Access Compliance Report

Public Rights-of-Way

Intersection ID: 10031302	Main Street: MARYLAND_AV	Cross Street: N/A	Location: NW
ADA ID: 2E16ECEBD5D9	Ramp Type: PerpDiag	Initial Pass/Fail: Fail	Overall Compliance: No
Severity Score: 10			
Codes/Mitigation Info/Possible Solution		Field Measurements/Component Compliance

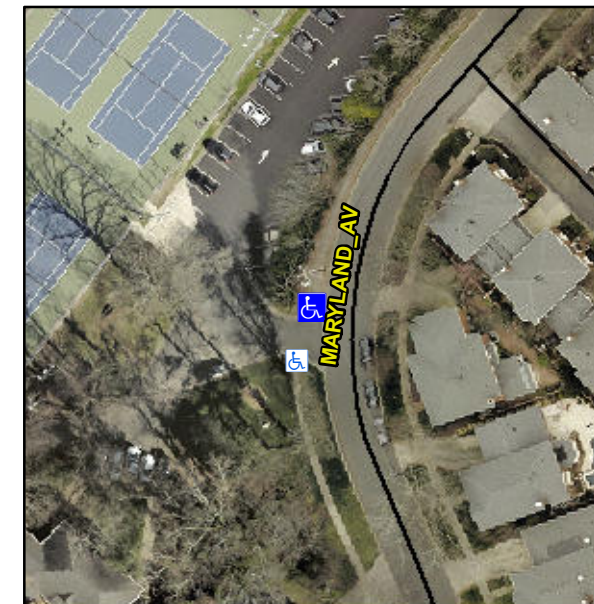
Not Found, R304.5.1, R304.5.3

Compliance	Description	Data	Compliance	Description	Data
N/A	Ramp Length (in)	26.0	Yes	Ramp Slope (%)	6.5
No	Ramp Width (in)	47.0	No	Ramp XSlope (%)	2.5
N/A	Flare Type LT	N/A	N/A	Flare Type RT	N/A
N/A	Flare Slope LT (%)	N/A	N/A	Flare Slope RT (%)	N/A
N/A	Flare Traversable LT?	N/A	N/A	Flare Traversable RT?	N/A
N/A	Landing Length (in)	N/A	N/A	DWS Provided?	N/A
N/A	Landing Width (in)	N/A	N/A	DWS Contrast?	N/A
N/A	Landing Slope (%)	N/A	N/A	DWS Length (in)	N/A
N/A	Landing X Slope (%)	N/A	N/A	DWS Full Width?	N/A
N/A	Landing Curb? (Y/N)	N/A	N/A	DWS Offset (in)	N/A
N/A	Shared Landing?	N/A			
N/A	Gutter Ponding?	N/A	N/A	Gutter Slope (%)	N/A
N/A	Gutter Lip Ht (in)	N/A	N/A	Gutter X Slope (%)	N/A
N/A	Painted X Walk1?	No	N/A	Painted X Walk2?	No
	X Walk 1 Direction	To SW		X Walk 2 Direction	To SE
N/A	X Walk 1 Width (in)	N/A	N/A	X Walk 2 Width (in)	N/A
	X Walk 1 Slope (%)	0.9		X Walk 2 Slope (%)	7.1
	X Walk 1 X Slope (%)	9.5		X Walk 2 X Slope (%)	0.9

Remove & Replace Curb Ramp With Two New Directional Ramps or Equivalent.
